Access Compliance Report

Public Rights-of-Way

(Curb Ramps)

Intersection ID: 15568	Main Street: KENILWORTH_AV	Cross Street: ORDERMORE_AV	Location: NE
ADA ID: 458A4CF71D4C	Ramp Type: Directional1	Initial Pass/Fail: Fail	Overall Compliance: No
Severity Score: 33.75			
Codes/Mitigation Info/Possible Solution		Field Measurements/Component Compliance

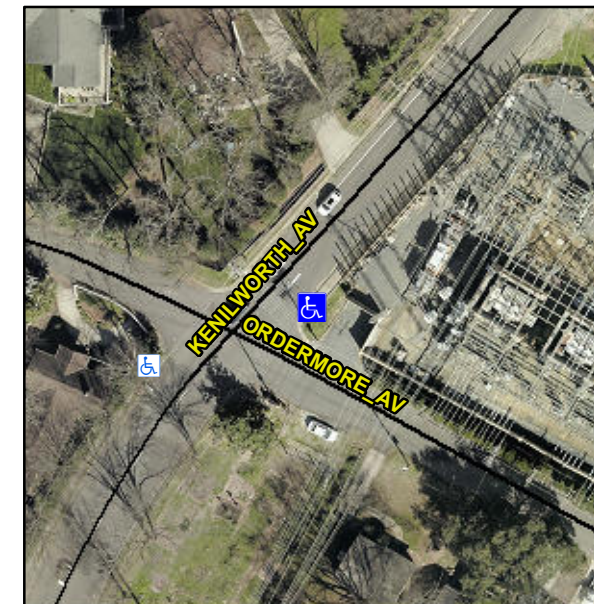
PROW/ADA:

R304.5.1, R304.2.2

Compliance	Description	Data	Compliance	Description	Data
N/A	Ramp Length (in)	56.0	N/A	Grade Break?	N/A
No	Ramp Width (in)	44.0	N/A	Grade Break Slope (%)	0.0
No	Ramp Slope (%)	19.9	N/A	Grade Break XSlope (%)	0.0
Yes	Ramp XSlope (%)	1.7			
N/A	Flare Type LT	N/A	N/A	Flare Type RT	N/A
N/A	Flare Slope LT (%)	N/A	N/A	Flare Slope RT (%)	0.0
N/A	Flare Traversable LT?	N/A	N/A	Flare Traversable RT?	N/A
N/A	Landing Length (in)	0.0	N/A	DWS Provided?	N/A
N/A	Landing Width (in)	0.0	N/A	DWS Contrast?	N/A
N/A	Landing Slope (%)	0.0	N/A	DWS Length (in)	N/A
N/A	Landing X Slope (%)	0.0	N/A	DWS Full Width?	N/A
N/A	Landing Curb? (Y/N)	N/A	N/A	DWS Offset LT (in)	N/A
N/A	Shared Landing?	N/A	N/A	DWS Offset RT (in)	N/A
N/A	Gutter Ponding?	0.0	N/A	Gutter Slope (%)	N/A
N/A	Gutter Lip Ht (in)	0.0	N/A	Gutter X Slope (%)	N/A
N/A	Painted X Walk1?	No		Road Slope (%)	7.3
	X Walk 1 Direction	To NW		Road X Slope (%)	8.8
	X Walk 1 Width (in)	N/A		Clear Space?	N/A

Possible Solutions:

Remove & Replace Entire Ramp.
